Company	Trenz Electronic GmbH
PCN Number	PCN-20250505
Title	TE0808-05 Ferrite Bead Change
Subject	BOM Change
Issue Date	2025-05-05

2.1 #1 Changed ferrite bead (L1 ... L5, L7) from BKP0603HS121-T to MPZ0603S121HT000.

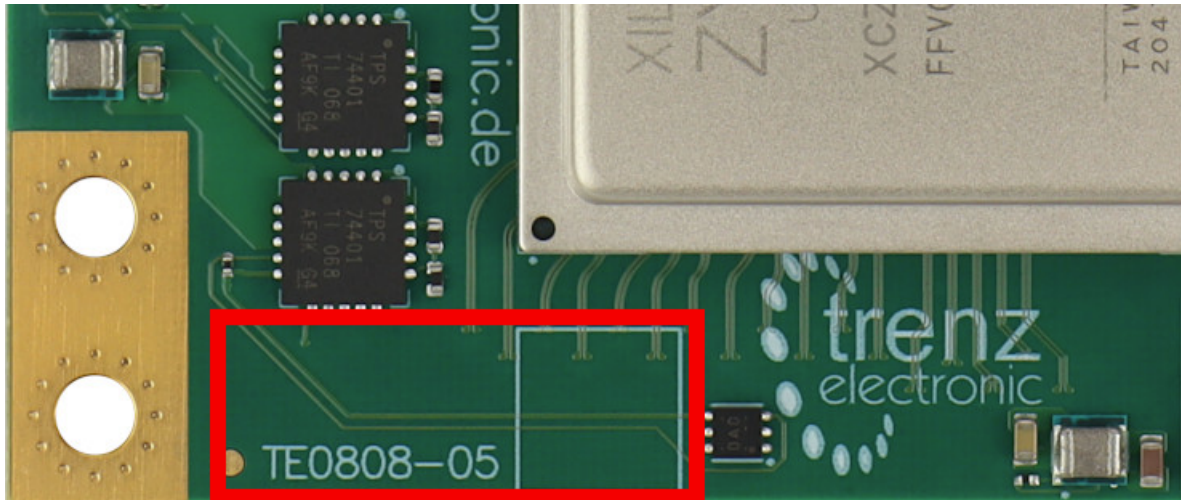
Type: BOM Change

Reason: EOL of component.

Impact: Increase current capability, decreased DC resistance and minor changes in electrical characteristics.
